**NAVY RESPONSES TO AGENCY COMMENTS  
ON THE DRAFT ALTERNATIVE SELECTION REPORT  
INTERIM-ACTION GROUP 5 SITES  
NAVAL STATION TREASURE ISLAND  
HUNTERS POINT ANNEX  
SAN FRANCISCO, CALIFORNIA**

**February 25, 1994**

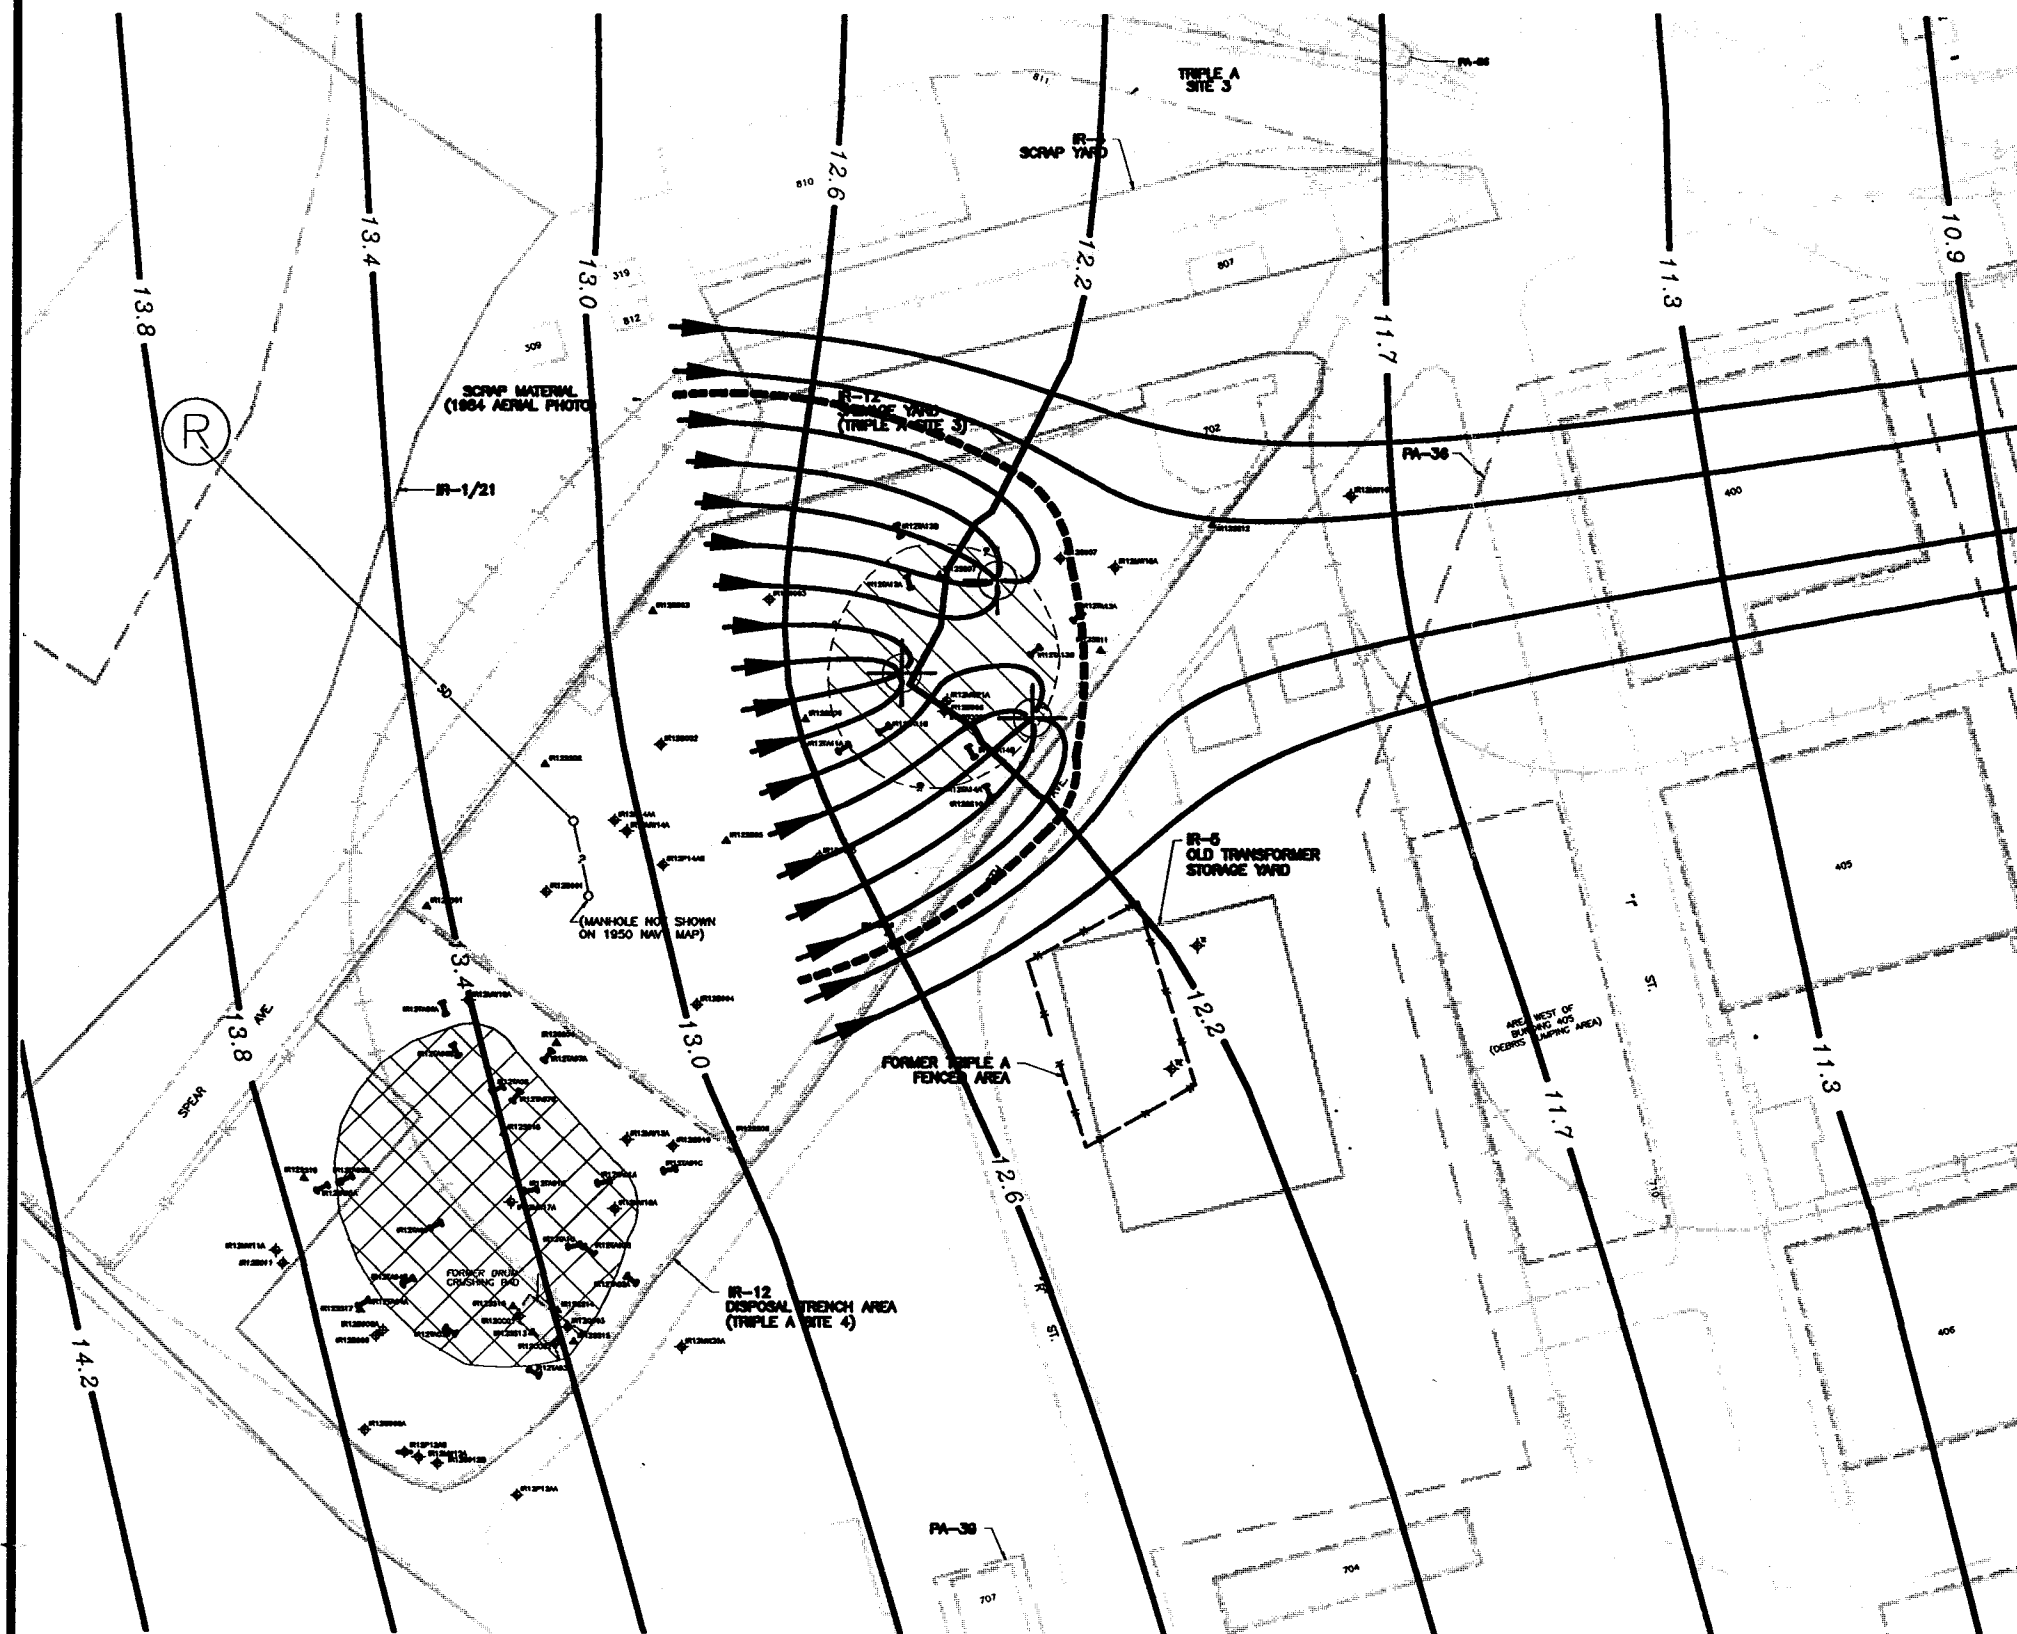
**Comment 10:** Figure F-1 shows the streamlines of groundwater flow to the extraction wells and not the groundwater elevation contours. The Figure should identify the groundwater elevation contours at steady state superimposed with the extent of the free product, in order to illustrate that the free product is effectively captured.

**Comment 12:** To efficiently capture the free product from groundwater, a trade off between the number of wells and flow rate should be considered. A drawdown analysis using a one-dimensional unconfined aquifer model indicated that the proposed pumping scheme may not be able to capture the free product plume. Additional extraction wells may be needed to completely capture the free phase hydrocarbon plume at Site IR-12.

**Response:** Figure F-1 showed the locations of wells and groundwater elevation contours at steady state superimposed on the extent of free product. Revised Figure F-1 includes a free product capture zone contour and is included as Attachment A of this document.

**Response:** A two-dimensional model indicated that the proposed pumping scheme would be able to capture the free product plume (see revised Figure F-1 for the estimated free product capture zone). The pilot study will determine whether additional extraction wells may be needed; if necessary, they will be incorporated into the design of a full-scale extraction system.

Maximum Copper, Mercury, Lead, and Zinc Concentrations  
in Soil, 0- to 2.5-foot Depth Interval, Site IR-13  
Group 5 Alternative Selection Report  
Naval Station Treasure Island  
Hunters Point Annex  
San Francisco, California

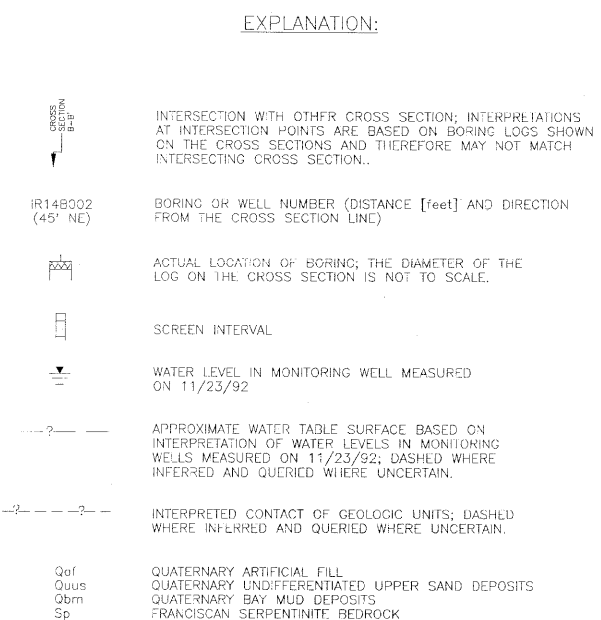
**Comment 7:** Although, plate 32 data indicate areas of high contamination, there are not TOG and Diesel contour maps for IR-13. Please explain why TOG level of 170,000 ppm at IR-13 should not be considered for an interim removal action. It seems likely that a final remediation is needed, thereby satisfying the second objective on page ii. Also, please explain why no removal action is recommended at site IR-13 when Plate 31 shows area of lead and mercury contamination. Further, the lead contour map presents contamination smaller in area than what it appears to be from the data. The map does not include IR13B00B3. Please explain.

**Response:** Elevated concentrations of TOG at Site IR-13 are isolated from one another, and are not amenable to contouring. The contours shown on the version of Plate 31 in the Draft ASR were in error; a revised Plate 31 is included in Attachment A of this document. Please see Response to DTSC Technical Comment 14.

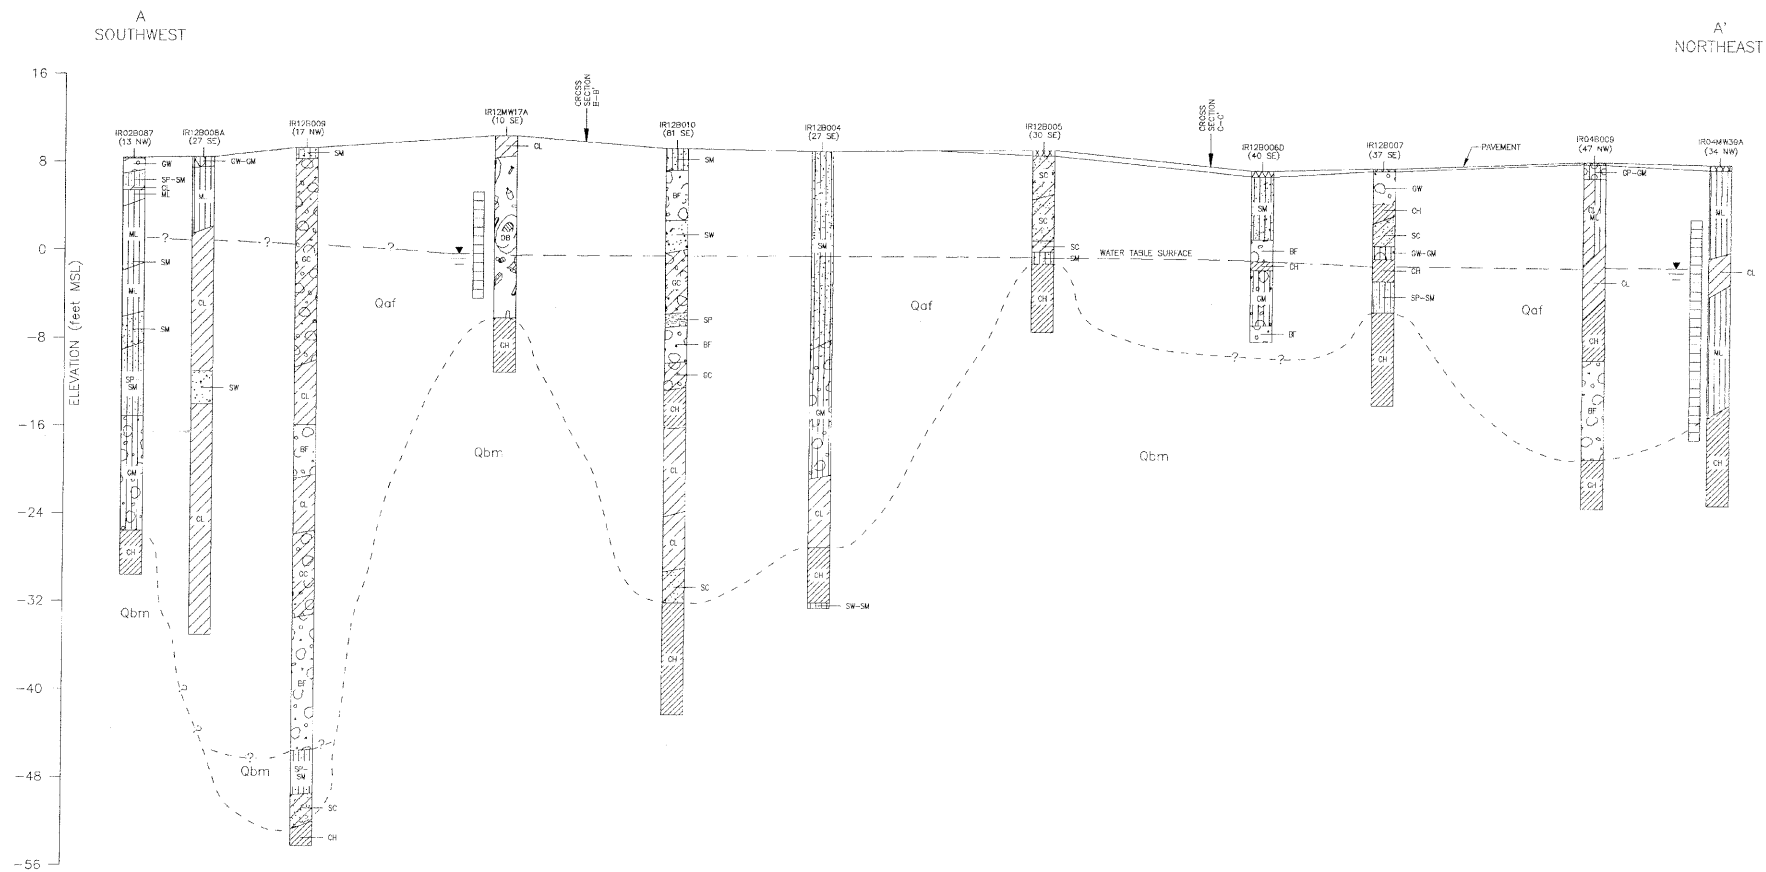
**Comment 19:** Plate 7 and 3, the cross section Plate 3, what happened to 12MW21A, 12B006 and many others? Where is B-B'? Where is C-C'?

**Response:** Please see Response to DTSC Technical Comment 18. Boring IR12B006D was chosen for depiction on cross sections A-A' and C-C' because soil chemical data were available from this boring. The intersections of cross sections B-B' and C-C' with A-A' were not shown on Plate 7; this was an oversight. Revised Plate 7 is provided in Attachment A of this document. Cross sections B-B' and C-C' were shown on Plates 27 and 28, respectively, of the ASR.
